**GE Hitachi Nuclear Energy**

**Subject: Response to NRC RAI Letter No. 299 Related to ESBWR Design  
Certification Application – DCD Tier 2 Section 3.8 – Seismic  
Category I Structures; RAI Numbers 3.8-107 S03**

**RAI Number 3.8-107 S03**

**Figure 3.8-107 (1) Output of Maximum Stress Ratios (Sample)**

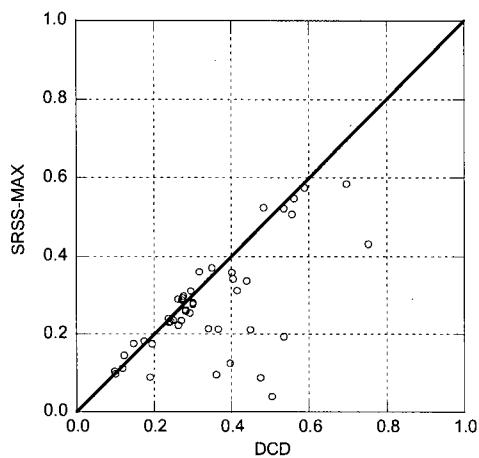
- a) How does SSDP flag instances where reinforcement provided is less than the demand?
- b) How does SSDP identify governing load combinations and the corresponding loads on a given finite element?
- c) How does SSDP apply the reinforced concrete codes used in the United States, such as ACI 349, ASME Section III, Div 2, and how are the code editions that are accepted by the NRC incorporated in the SSDP to keep it current?
- d) How is the reinforcement pattern (radial and circumferential or rectangular grid) interpreted in the SSDP?
- e) How does the SSDP identify critical sections of a structure?
- f) In the reinforced concrete containment structure, how does SSDP evaluate the tangential shear stress to demonstrate compliance with the ASME Code?

- a) In the post-processing routine of the SSDP-2D, the maximum calculated stresses are compared with the allowable stresses, and stress ratios, i.e., ratio of calculated stress to allowable stress, are calculated. The maximum stress ratios obtained can be plotted on the finite element meshes as shown in Figure 3.8-107(1). In the

figure, stress ratios exceeding 1.0, i.e., the maximum stress is larger than the allowable, are identified in a different color. This procedure is used to find the elements where reinforcement provided is less than the demand.

- b) The ID numbers of the load combinations which generate the maximum stress ratios are also indicated in Figure 3.8-107(1). The governing load combinations are also shown on the figure.

Figure 3.8-107(6) Comparison for SRSS Bound Case (Load ID = 7441)

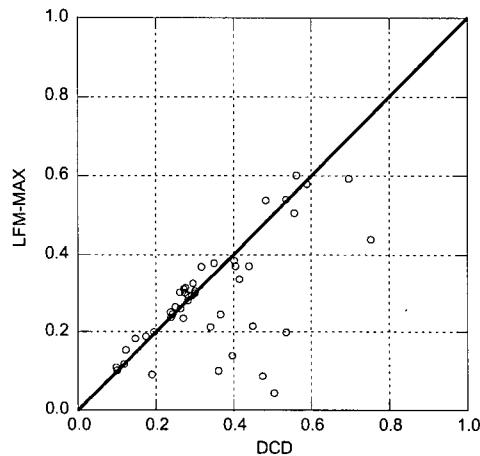
(3) *Figures 3.8-107(6)(b) and (10)(b) show one point where the SRSS and RG1.92 100/40/40 methods of spatial combination produce results significantly higher (factor of 2.5 to 3) than the DCD method. Please explain this large difference, and provide the technical basis for considering this large difference to be acceptable.*

- (3) Figures 3.8-107(6)(b) and 3.8-107(10)(b) are replaced by Figures 3.8-107(15)(b) and 3.8-107(19)(b), respectively, and no longer show the large differences noted. The large differences in these Figures was due to an error and has been corrected as discussed in the response to NRC RAI 3.8-107, Supplement 2, Item (a)(1).

**Figure 3.8-107(22) Schematic for Section Cuts, Elevation View**

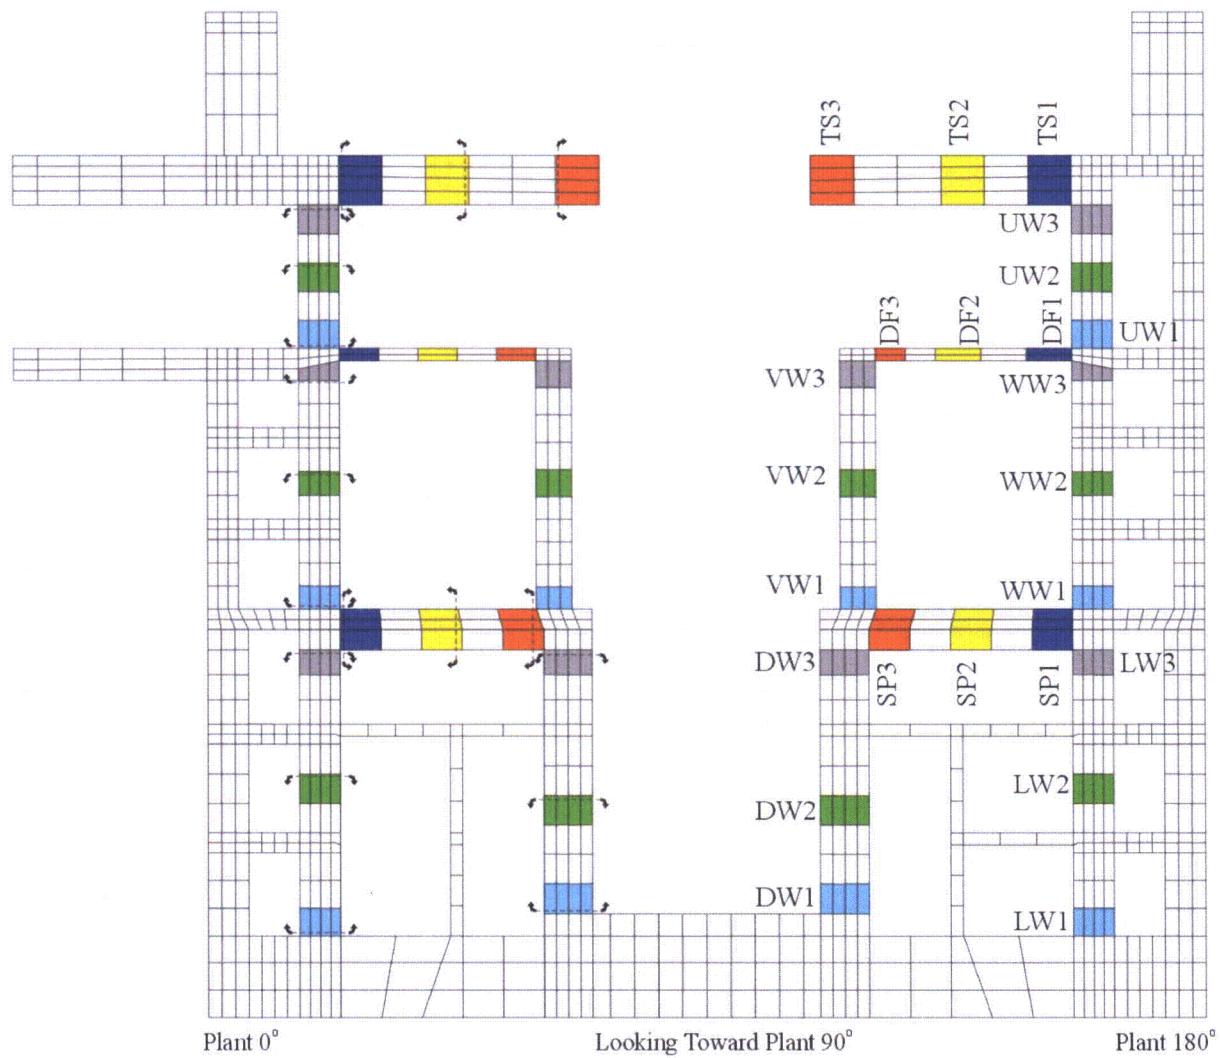
*The staff has a concern that combining the nonlinear thermal stress analysis results with the elastically calculated results for other loads may not be appropriate. The correct approach, because of the significant nonlinear behavior evident in the ABAQUS/ANACAP thermal analysis, would be to apply all simultaneously occurring loads at the same time using the ABAQUS/ANACAP nonlinear model. In the presence of significant nonlinear behavior, linear superposition of results due to different applied load sets may lead to significant errors in the final combined loading response.*

*The staff requests the applicant to provide a detailed technical basis for the acceptability of its approach. Example comparisons for element 1824 and several other representative locations should be included in the response.*

- (c) A demonstration analysis is performed to provide a basis for addressing this issue. The demonstration uses the detailed 3D ABAQUS/ANACAP finite element model. The first case considers a linear analysis for pressure loads combined with the

nonlinear cracking analysis for thermal loads. For this case, the nonlinear cracking analysis is performed for the DBA thermal conditions at 72 hours. The DBA thermal conditions at 72 hours are considered for the demonstration because this condition maximizes the effect of thermal induced cracking with the deepest penetration of temperatures into the concrete walls. A separate linear analysis is then performed for application of the DBA pressure loads (no concrete cracking), and the stress results, both concrete compression and rebar tension, from these 2 analyses are added together. Thus, Case 1 provides the linear based stresses due to pressure combined with the nonlinear calculated stresses due to thermal. Case 2 then considers a true nonlinear analysis where both the pressure and temperature loads are applied simultaneously and incrementally with concrete cracking and stress redistribution. The maximum concrete compressive stresses and the maximum rebar tensile stresses are then compared between Case 1 and Case 2 for the section cuts used in calculating the thermal ratios from the previous analyses.
